TECHNICAL NOTES SERIES

JOWETT JAVELIN – PA, PB, PC, PD & PE

JOWETT JUPITER – SA & SC

PART III – SERVICE BULLETINS – JAVELIN AND JUPITER

Figure 1. Dimensions for drilling fan support tube.

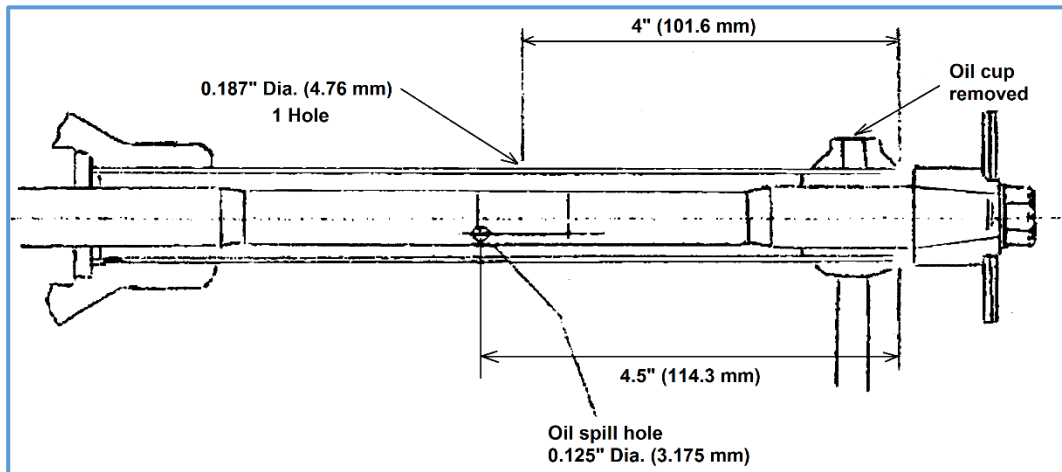
With the introduction of the radiator mounted oil cooler the fan support tube oil cup, Part Number J54011, was inaccessible and therefore removed. A 3/16" (4.7625 mm) hole is now incorporated in the fan support tube for lubrication purposes together with a 1/8" (3.175 mm) spill hole to prevent over lubrication.

Right: Figure 1. Showing the stepped second compression ring.

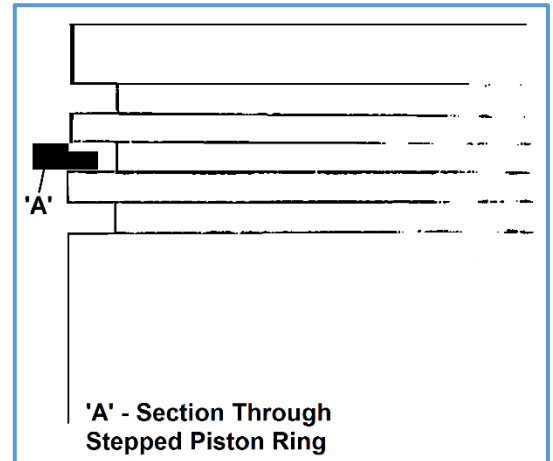
From Engine Number E0 PB 8345 a new type of cylinder liner, Part Number 54019, has been fitted. This liner can be identified by the fact that the flange which locates with the crankcase set (50522/3) is larger than on the original type, Part Number 50642. A new type piston, Part Number 50656BG, and second compression ring, Part Number 54021, have also been introduced for use with this liner. The piston has the letters 'BG' stamped on the crown and the second compression ring has an internal step which should be fitted as shown in the illustration at right.

Figure 1. Location of grease release hole.

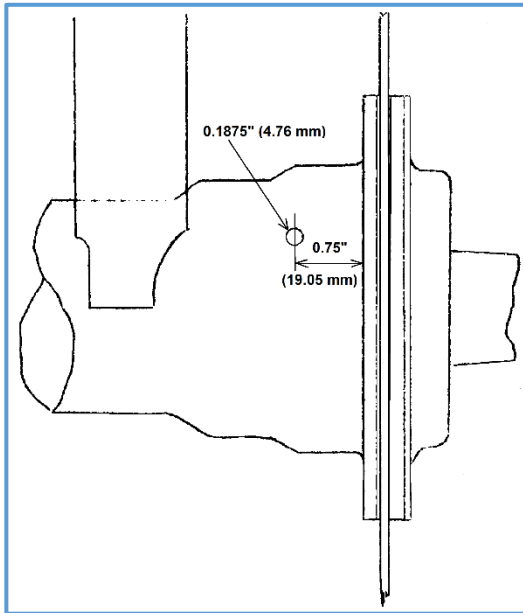
Cases have been reported where an over application of grease to the rear hubs has resulted in brake lining contamination and subsequent brake inefficiency. A $\frac{3}{16}$ " (4.7625 mm) diameter grease relief hole will shortly be incorporated for all rear hub bearings at the rear and outer (hub) end of the axle casing tubes, as shown in the sketches below:

When greasing rear hubs embodying this feature, hubs should be lubricated until grease just appears from the relief hole.

Right: Figure 2. Section through rear axle tube, showing angle of grease hole.

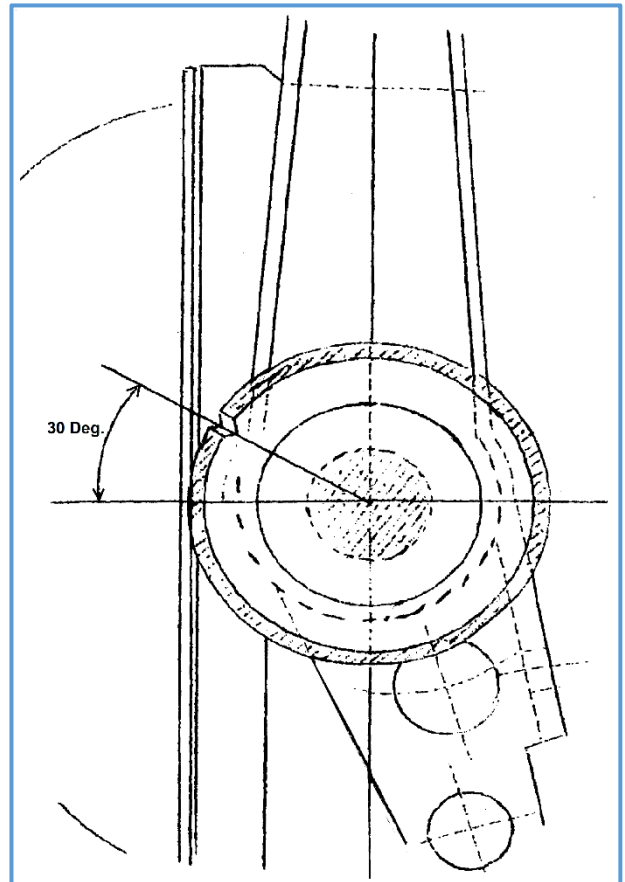
Side elevation sketch, refer to Figure 2 at right.

Right: Figure 1. Detail of clearance cut out at cylinder liner.

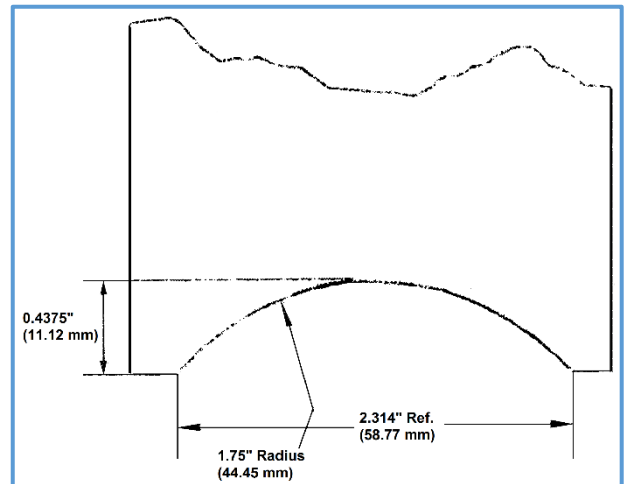
When fitting the new type connecting rod to engines previous to number E0 PB 10506 or when replacing cylinder liners in engines fitted with the new type connecting rods, it is most **important** to check the clearance between the connecting rod and the skirt of the cylinder liner. The liner cut out may be modified as detailed in the sketch below.

Depth of cut-out in cylinder liner skirt	0.437" (11.10 mm)
Width of cut-out at cylinder liner edge	2.314" (58.77 mm)
Cut-out radius	1.750" (44.45 mm)

Right: Figure 1. Front shock absorber lower mounting.

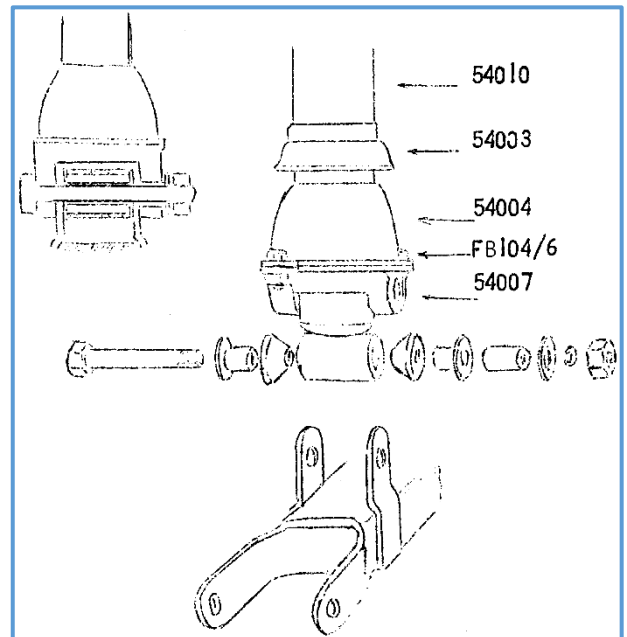
From Engine Number E0 PB 9877 a new type of front shock absorber has been fitted to Javelin cars. These units incorporate a re-designed lower fixing arrangement which reverses the position of the shock absorber buffer as shown in the sketch at right.

It will be noted that the buffer assembly is cut away to provide clearance for the stub axle in the rebound suspension position.

Right: Figure 1. Steering ball joint components.

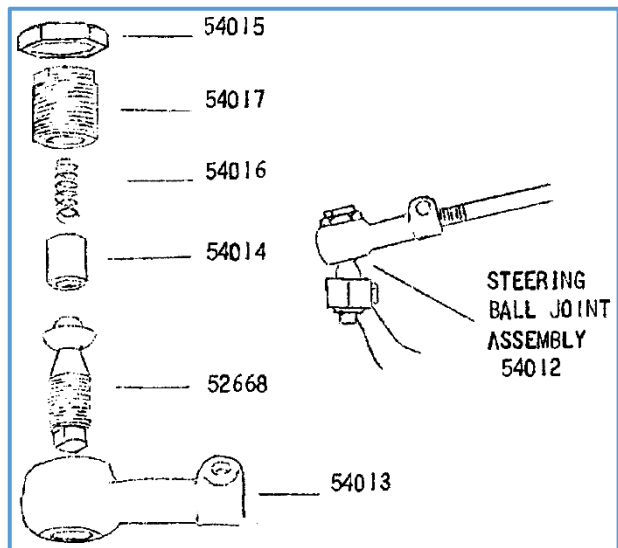
A re-designed steering ball joint assembly, Part Number 54012, has been fitted to all Javelin cars with effect from Engine Number E0 PB 10789, as shown in the sketch below:

The new assembly has been designed for ease of dismantling and is fully interchangeable with the previous type of steering ball joint assembly. To adjust the spring tension, release the lock nut, Part Number 54015, and screw the spring retaining nut in a clockwise direction until solid. From this point release the spring retaining nut a quarter of a turn and lock with the lock nut, Part Number 54015.

Right: Figure 1. Adjustable gear change links.

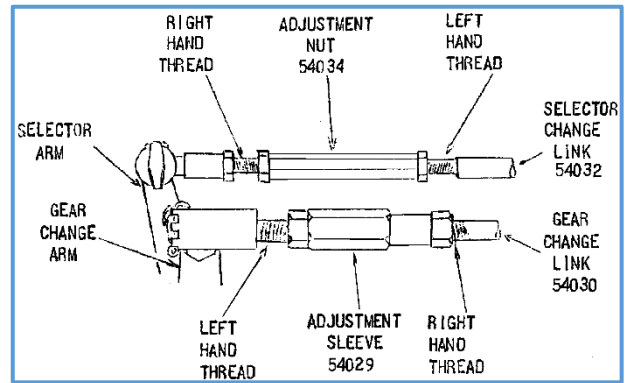
From Engine Number E0 PC 12340 new type adjustable selector, Part Number AS54031, and gear change, Part Number AS54027, link assemblies have been fitted between the gear change column and gearbox on RHD models only. This modification allows a finer and increased range of adjustment on each rod.

Adjustment: The adjustment nut, Part Number 54034, on the selector change link and the adjustment sleeve, Part Number 54029, on the gear change link are provided with left and right hand threads which allow the link to be lengthened or shortened by turning the nut or sleeve after the locknuts have been released. Please refer to the illustration above. The direction of rotation for adjustment works in opposite directions on each link i.e. to lengthen the selector change link the top of the adjustment nut should be turned away from the operator, whereas to lengthen the gear change link the top of the adjustment sleeve should be turned towards the operator.

Figure 1. Modified air cleaner bracket arrangement.

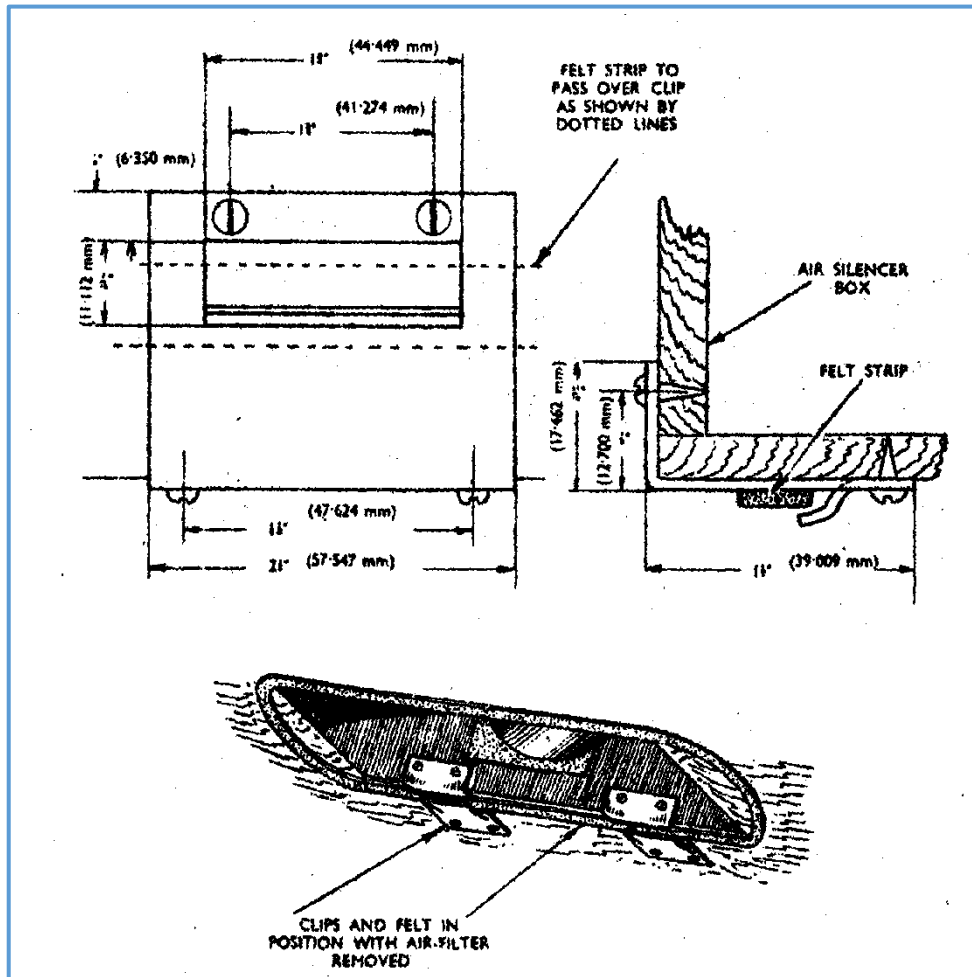
With effect from Engine Number E0 PB 8950 the woodscrews which secure the air filter brackets to the air silencer base, have been replaced by threaded screws and rivet nuts. On cars prior to the above Engine Number where difficulty is experienced with the original filter mounting, modified securing brackets may be fitted. This type of bracket, Part Number 54237, is held firmly in position by four wood screws set at right angles to each other, as shown in *Figure 1*.

Arrangements have been made for the modified brackets to be supplied from our Spares Department.

Right: Figure 1. Location of sludge release hole.

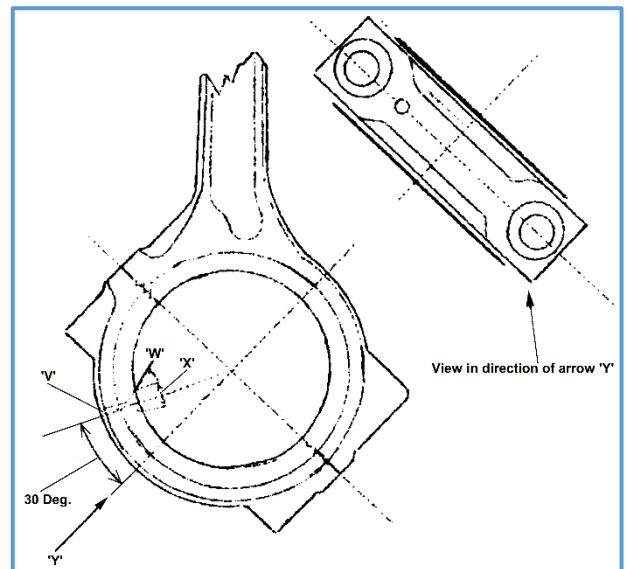
From investigations we have recently carried out, we consider it desirable to incorporate a sludge release hole in the connecting rod cap and bearing. This modification has been incorporated from Engine Number E1 PC 17402, and takes the form of a $\frac{1}{16}$ " (1.5873 mm) hole drilled 30° off centre of the connecting rod cap.

The connecting rod bearing, Part Number 52574, has also been drilled $\frac{1}{4}$ " (9.35 mm) diameter to correspond with the connecting rod drilling.

Legend: 'V' – Drill $\frac{1}{16}$ " (1.58 mm) dia, hole through bug end cap, de-burr at 'V'. 'W' – Countersink at 45° included angle. 'X' – Countersink width $\frac{5}{32}$ " (3.96 mm).

When vehicles prior to Engine Number E1 PC 17402 are in your service department for engine repairs, the opportunity may be taken to carry out the connecting rod modification as detailed in *Figure 1*.

Right: Figure 1. Third and top sliding sleeve and selector fork.

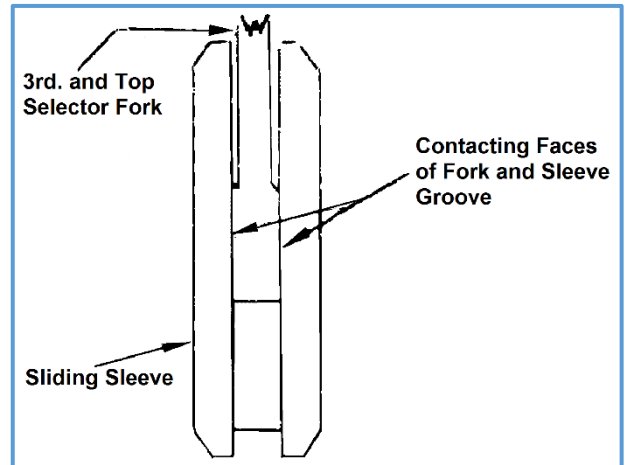
To prevent gear lever vibration the width of the third and top selector fork has been increased for a distance of approximately $\frac{5}{8}$ " (15.875 mm) from the ends of the fork by 0.020" (0.508 mm) as shown below. With this modification the $\frac{5}{8}$ " (15.875 mm) increased width portion of the fork only contacts the sliding groove when the sliding sleeve is being moved axially on the driving dog, thereby eliminating any tendency for the sliding sleeve to be incorrectly aligned when in full engagement with the gear dog teeth.

Right: Figure 1. Starter ring gear modification.

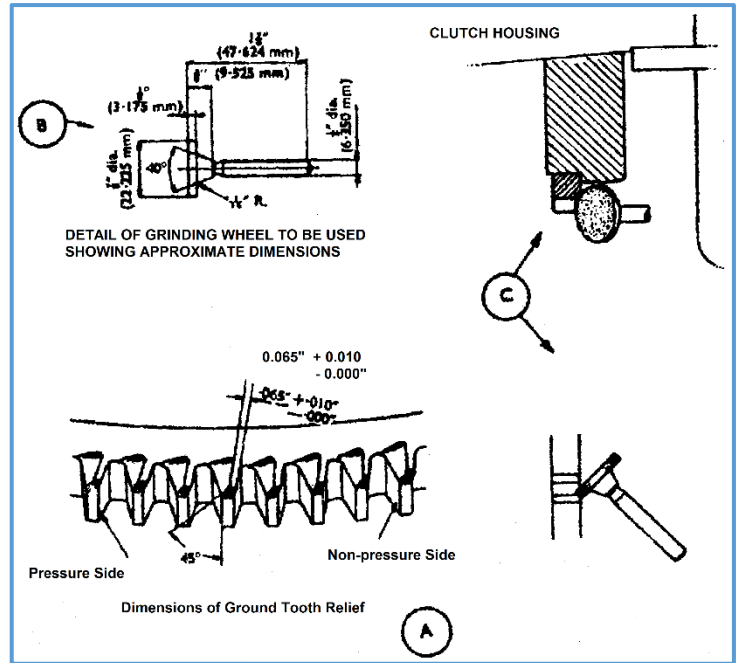
An increased tooth chamfer which runs parallel with the pressure side of the ring gear tooth is now incorporated on all flywheel ring gears fitted to Javelin and Jupiter cars. This modification gives improved 'lead-in' for the starter Bendix drive gear thereby cutting down to a minimum any tendency for the flywheel ring gear teeth to become burred or damaged due to initial contact between the two gears.

Figure 2. Installing Lucas DKY H4A distributor on later type timing cover.

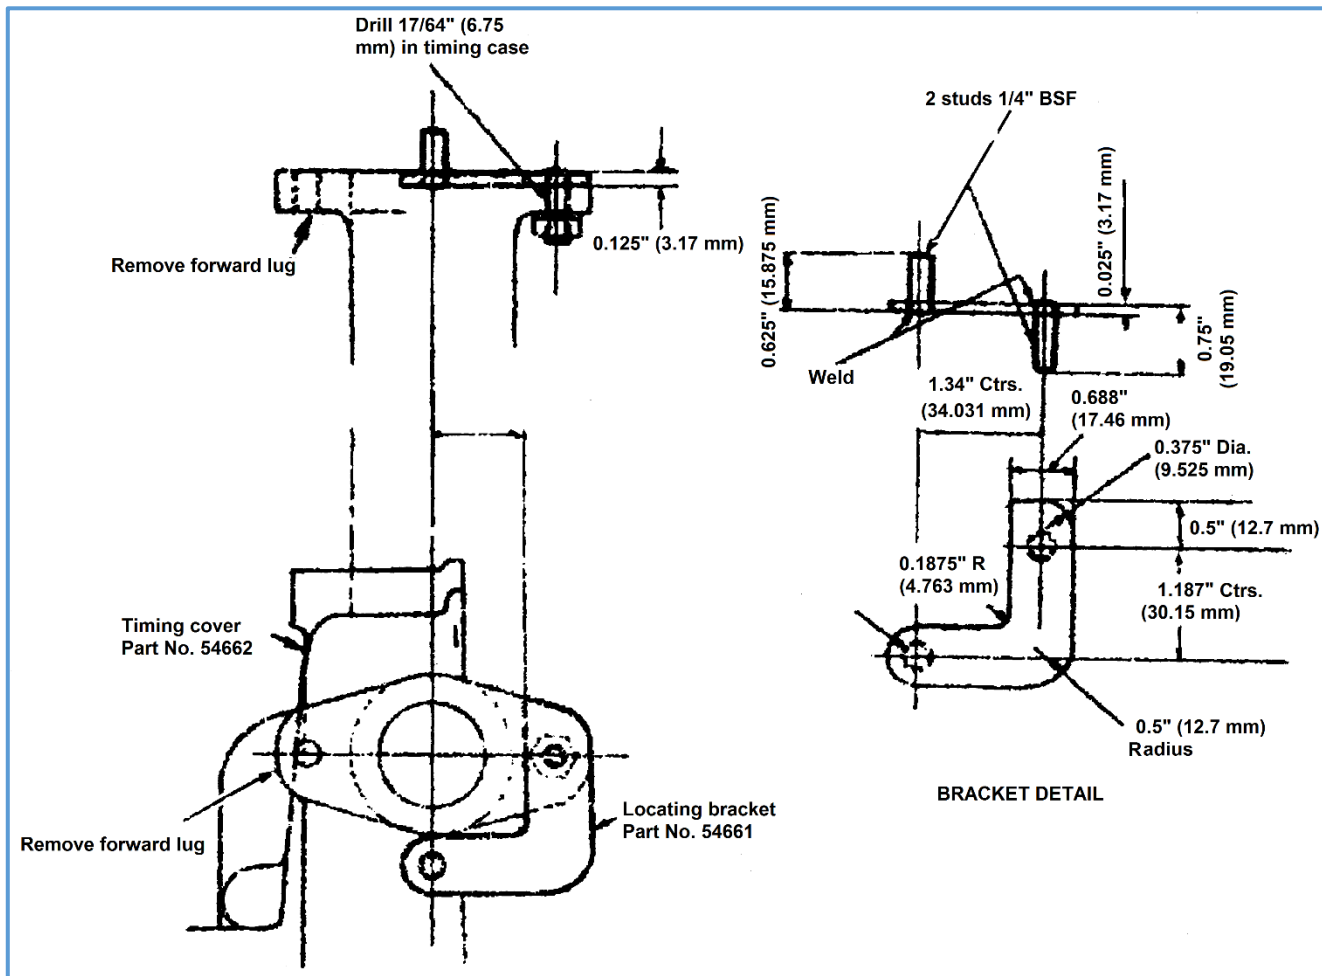
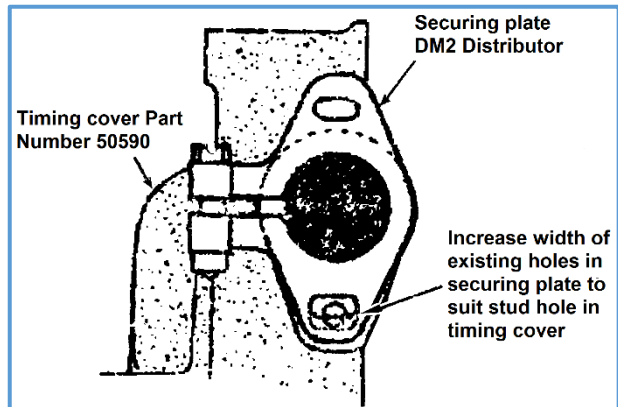
From approximately Javelin Engine Number E2 PD 21016 and Jupiter Engine Number E2 SA 717 the distributor type DKY H4A, Part Number 50773, is replaced by the DM2 type, Part Number J54516, which embodies a micrometer adjustment unit. The mounting flange on the timing cover is modified to suit the new type distributor securing plate and the new type timing cover, Part Number 54662, has also been changed. The DM2 distributor may be fitted to the old type timing cover by increasing the width of the elongated hole in the securing plate as shown in *Figure 1*.

The old type distributor (DKY H4A) can be fitted to the new type timing cover by removing the forward lug of the timing cover mounting flange and fitting a distributor locating bracket, Part Number 54661, to the rear lug of the timing cover mounting flange as shown in *Figure 2*.

Figure 1. Dimensions for drilling fan support tube.

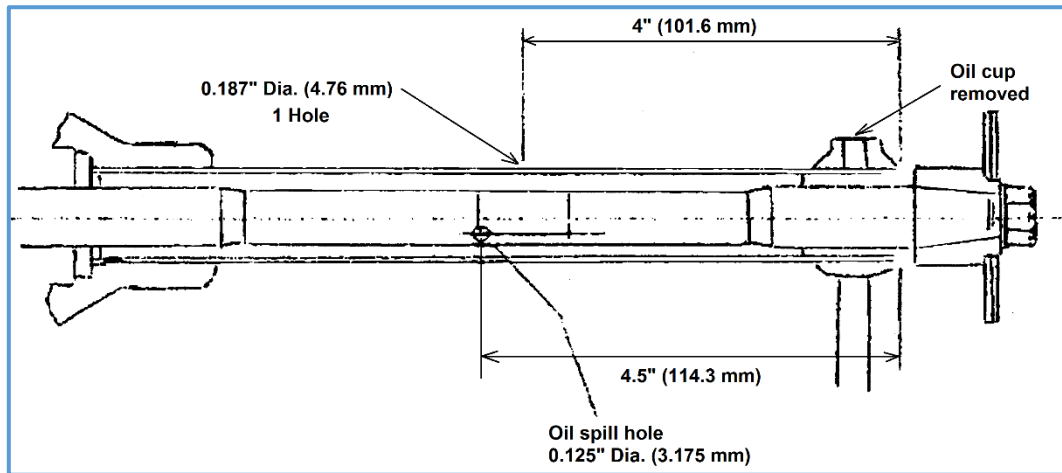
With the introduction of the radiator mounted oil cooler the fan support tube oil cup, Part Number J54011, was inaccessible and therefore removed. A $\frac{3}{16}$ " (4.7625 mm) hole is now incorporated in the fan support tube for lubrication purposes together with a $\frac{1}{8}$ " (3.175 mm) spill hole to prevent over lubrication.

Above and right: *Figure 1*. Modification to reverse selector lock lever.

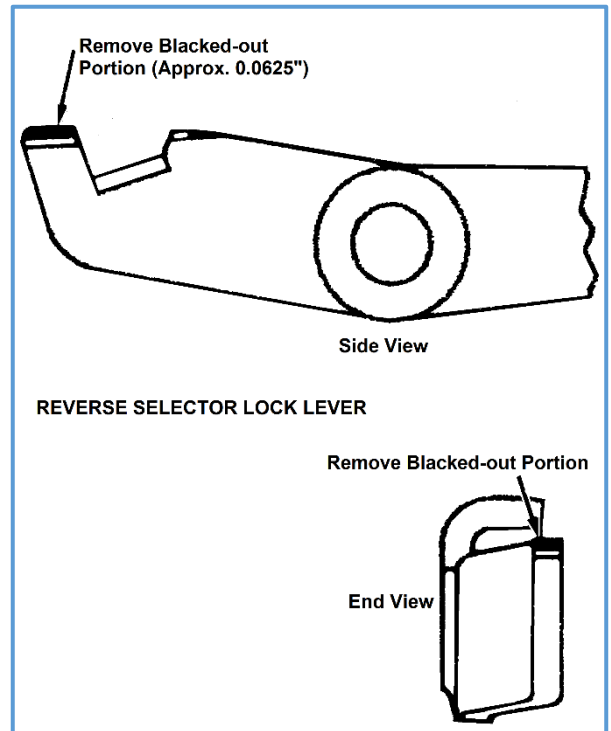
To eliminate this fault remove approximately $\frac{1}{16}$ " (1.6 mm) from the reverse selector lock lever and back off as shown in *Figure 1*.

Figure 1. Showing where material can be milled from cylinder head.

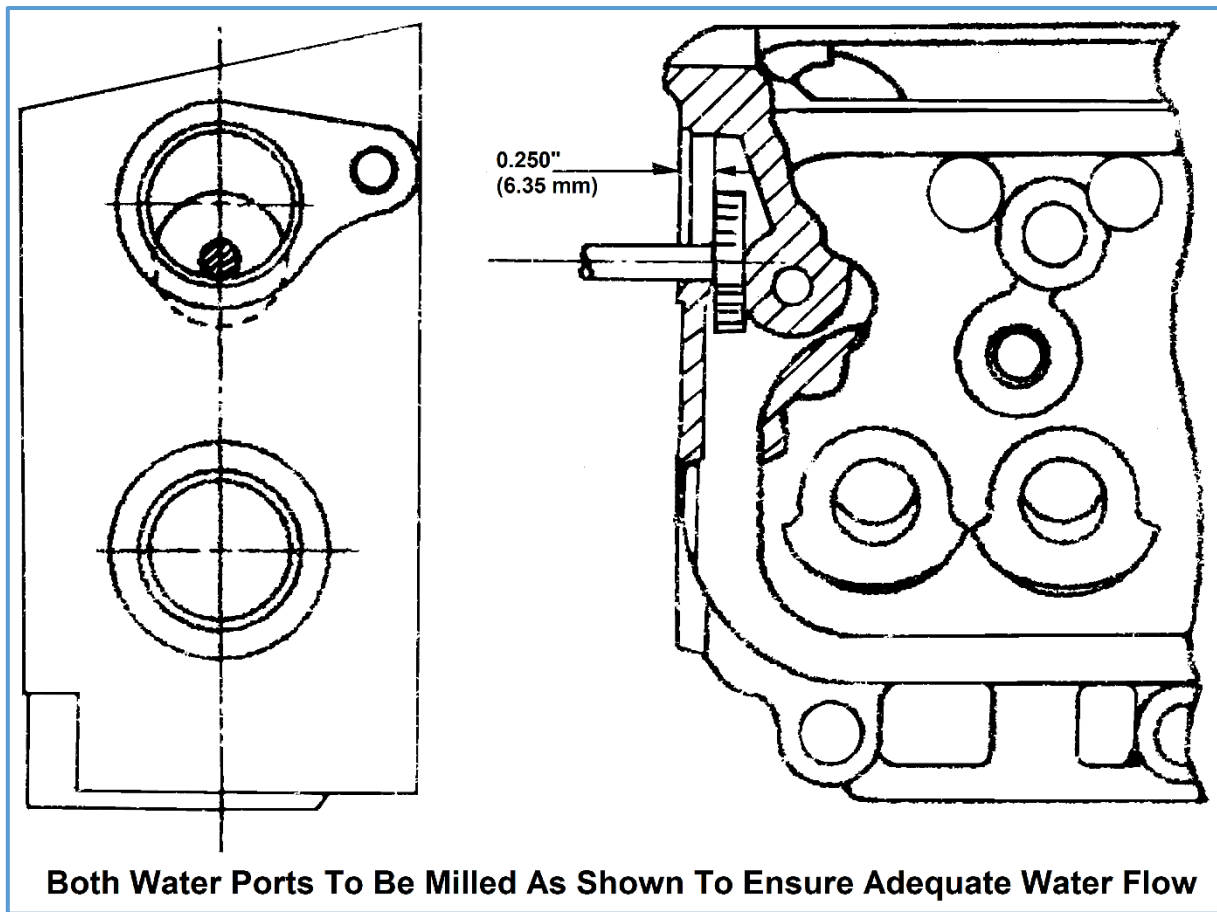
Cases have occurred where engine overheating and pinking has been caused by a restriction between the outer wall of the cylinder head and the cylinder head stud hole casting shown in *Figure 1*.

In cases of this nature an adequate water flow between these two points can be ensured by inserting a Woodruff cutter as shown in *Figure 2* through the cylinder head water port, *Figure 1*, and milling a ¼" (6.35 mm) passage between the cylinder head outer wall and the stud hole casting.
